## **COTTAGE OAKS SUBDIVISION**

APPLICATION NUMBER 12 DATE April 5, 2007

REQUEST Subdivision

## DETAIL SITE PLAN

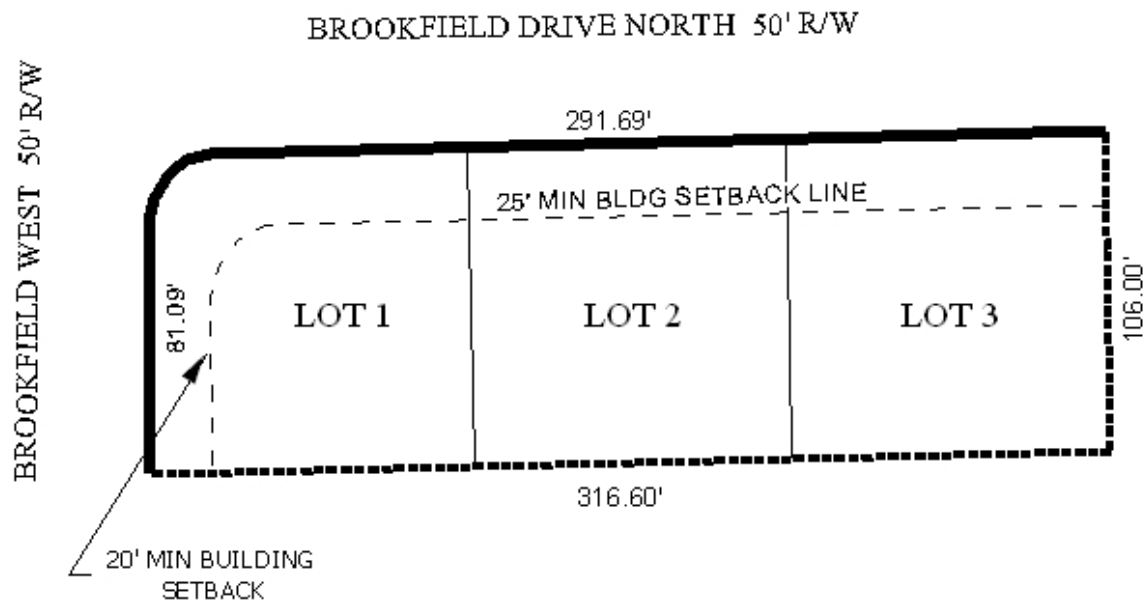
The site fronts onto Brookfield Drive North and Brookfield Drive West, both minor streets with adequate right-of-way. While each street is a minor street, access management is a concern. Proposed Lot 1 should be limited to one curb-cut either onto Brookfield Drive North or Brookfield Drive West, but not both, while Lots 2 and 3 should be limited to one curb-cut each, with the size, design and location of all curb-cuts to be approved by Traffic Engineering and comply with AASHTO standards.

The lots meet the minimum size requirements of the Subdivision Regulations and are labeled with their size in square feet. The size of Lot 1, however, is incorrect and should be corrected for the final plat, if approved.

The plat depicts a 25-foot minimum building setback line from Brookfield Drive North, but only a 20-foot setback line from Brookfield Drive West. The Subdivision Regulations require that the setback from all streets be 25-feet: a 20-foot sideyard setback is allowed on corner lots by the Zoning Ordinance in Single-Family Residential districts. If the applicant wishes to request a 20-foot setback, an application for Planned Unit Development should be provided and the Subdivision application should be heldover to coincide with the PUD application.

- 1) placement of a note on the final plat stating that Lot 1 is limited to one curb-cut either onto Brookfield Drive North and Brookfield Drive West, and that Lots 2 and 3 are limited to one-curb cut each, with the size, design and location of all curb-cuts to be approved by Traffic Engineering and conform to AASHTO standards;
- 2) correction of the label regarding the size of Lot 1 in square feet;
- 3) revision of the plat to show a 25-foot minimum building setback from all street frontages; and
- 4) full compliance with all municipal codes and ordinances.
